**METROPOLITAN GOVERNMENT OF NASHVILLE AND DAVIDSON COUNTY**

**STAFF RECOMMENDATION**  
**218 Mockingbird Road**  
**July 17, 2019**

**Application:** New Construction- Detached Accessory Dwelling Unit (DADU); Setback Determination

# ADDITION PLAN

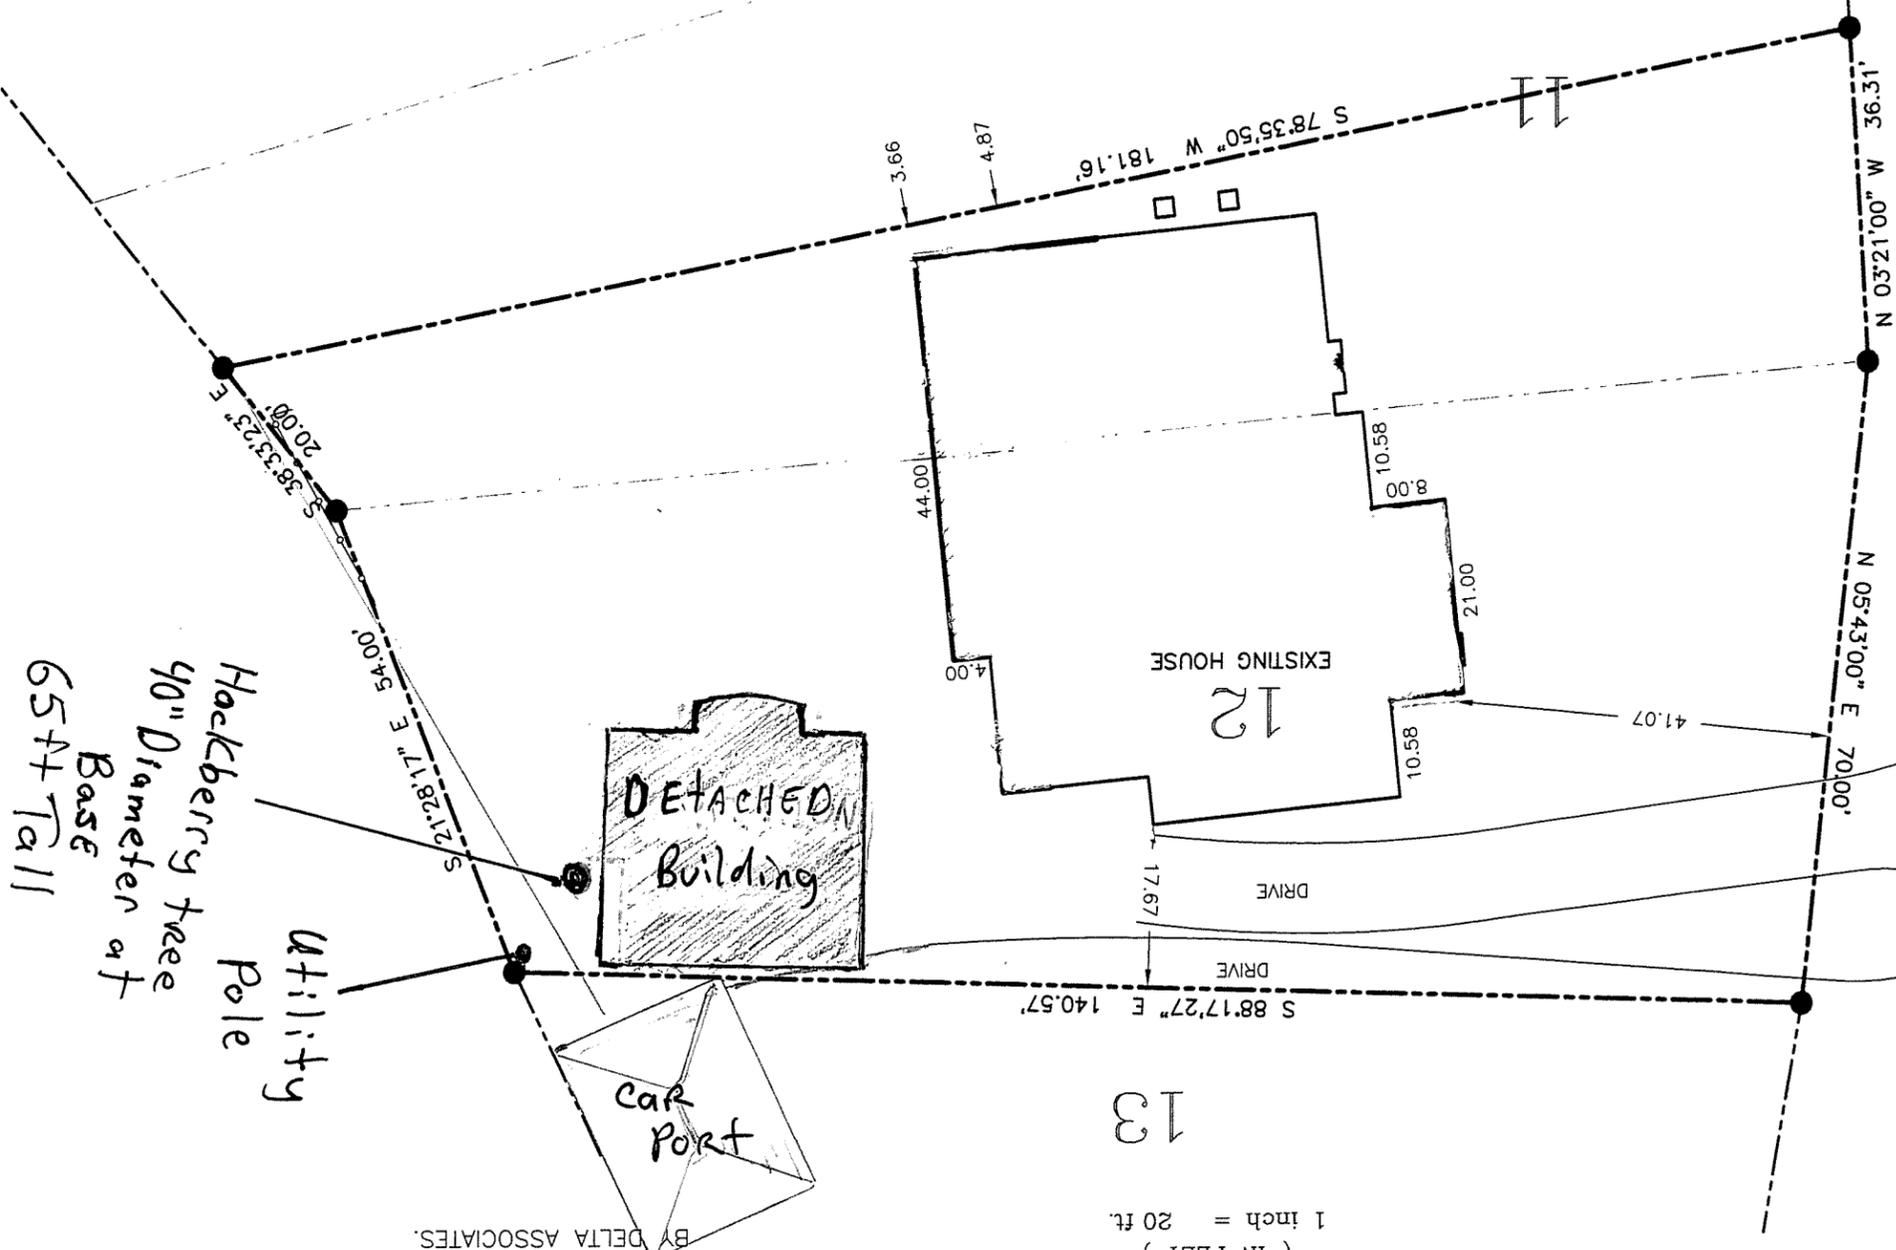
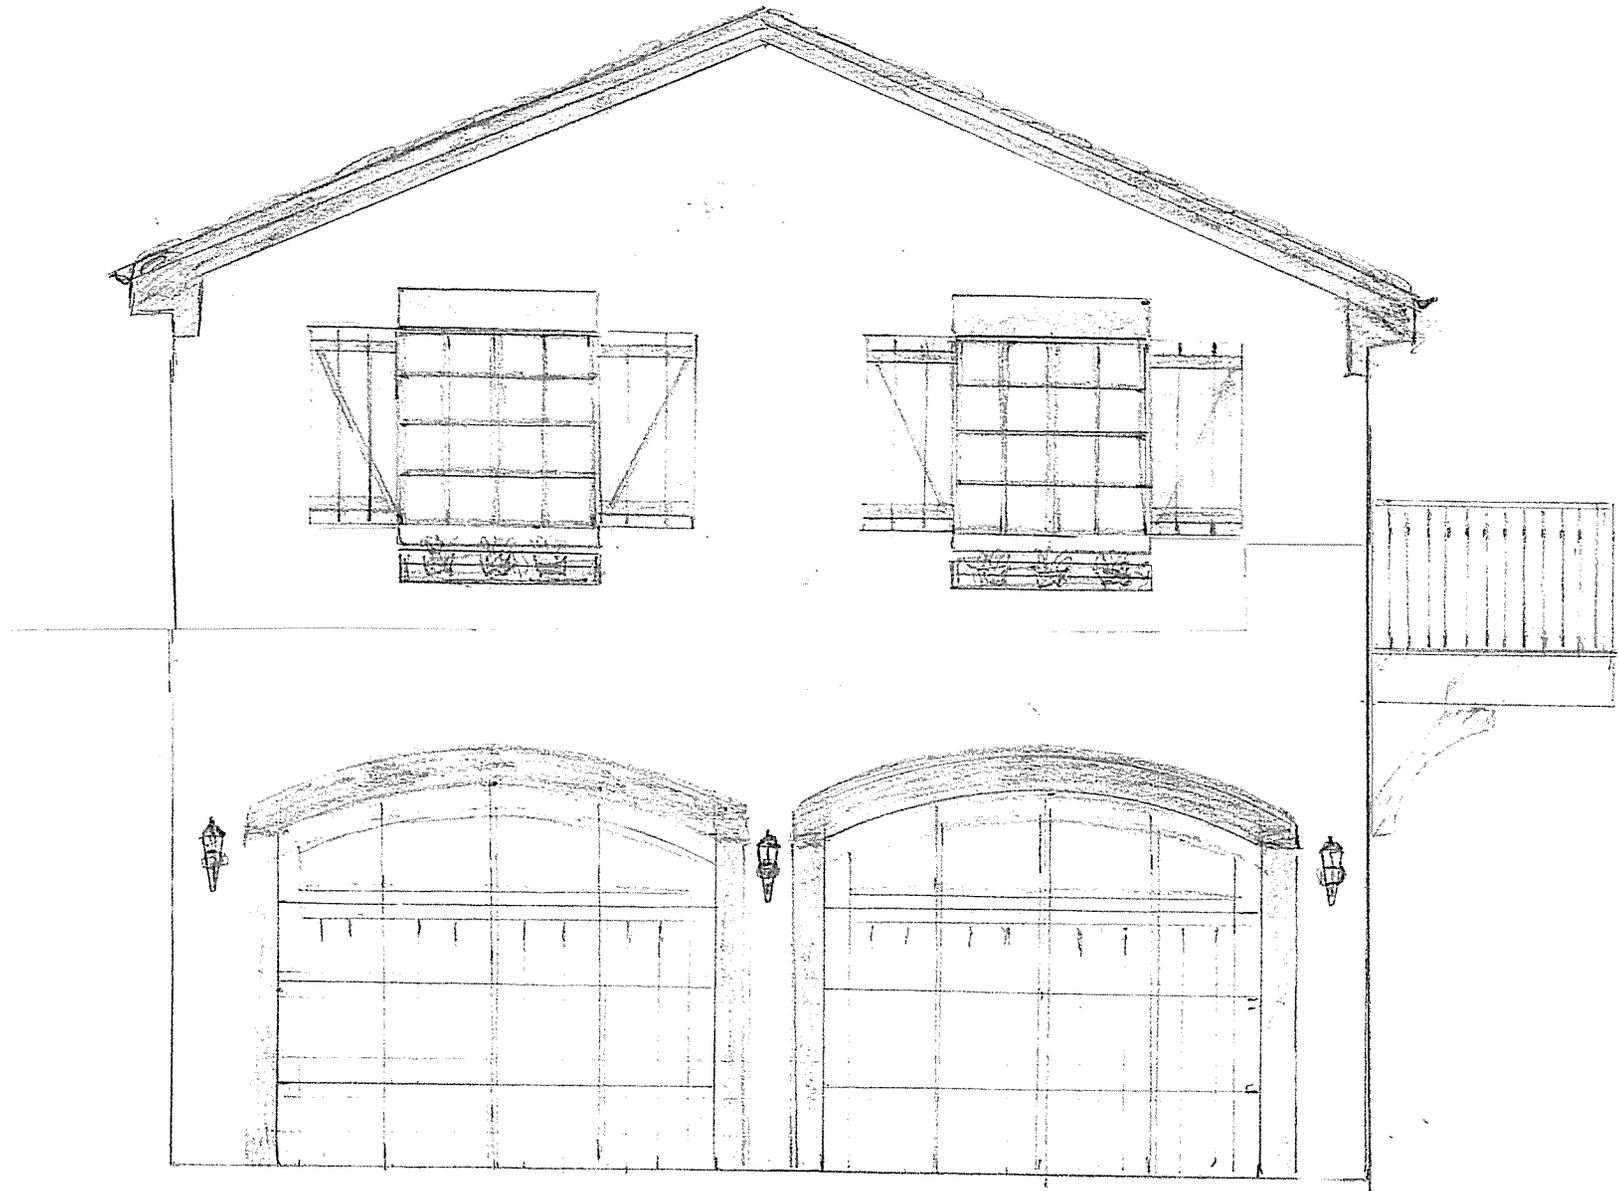
**Analysis and Findings:** The applicant proposes construction of a two-story detached accessory dwelling unit (DADU) behind the home. The applicant requests a setback determination from five feet (5') to one foot (1') for the left side.

The proposed outbuilding has a total footprint of seven hundred and sixty-three square feet (763 sq. ft.), the area being seven hundred and fifteen square feet (715 sq. ft.) plus forty-eight square feet (48 sq. ft.) for the balcony. For outbuildings with a footprint greater than seven hundred square feet (700 sq. ft.), the setback requirements are as follows:

Minimum	Proposed DADU
<b>Rear Setback</b>	3'	10'
<b>Right Side Setback</b>	5'	44'
<b>Left Side Setback</b>	5'	1'
<b>Distance between principal building &amp; outbuilding</b>	20'	14'

The outbuilding is proposed to be separated from the house by only fourteen feet (14'), as there is a large tree at the rear corner that the applicant wants to retain. The design guidelines require twenty feet (20') of space between the back of a house/addition and an outbuilding. In cases where lots are unusually shallow, have constraining easements, or are unusually shaped, the Commission has reduced the allowable depth to ten feet (10'). Because this lot is shallow at just one hundred and forty feet (140') on the left side, staff finds that a reduced distance of fourteen feet (14') between the rear of the house and the DADU could be appropriate in this case. The required side setback for a structure less greater than 750 square feet is five feet (5'). The applicant requests a setback determination for the left side of the outbuilding from five feet (5') to one foot (1') in order to conserve yard space and to be able to drive a vehicle straight into the garage. The Commission has regularly approved a reduced rear setback for an outbuilding, but has required the side setbacks to meet base zoning requirements. Because of the size of the DADU (square footage and two-stories) and because there is room on the lot to

relocate the garage to a different area, staff does not find it to be appropriate to reduce the side setback. Staff recommends the new structure be at least five feet (5') from the side property line to meet the requirements of Section II.B.h and 17.16.030.G for location and setbacks.

1. That the outbuilding is located at least five feet (5') from the left side property line to meet base setback requirements; and,
2. Staff have final approval of materials including trim, windows, doors and roofing color.
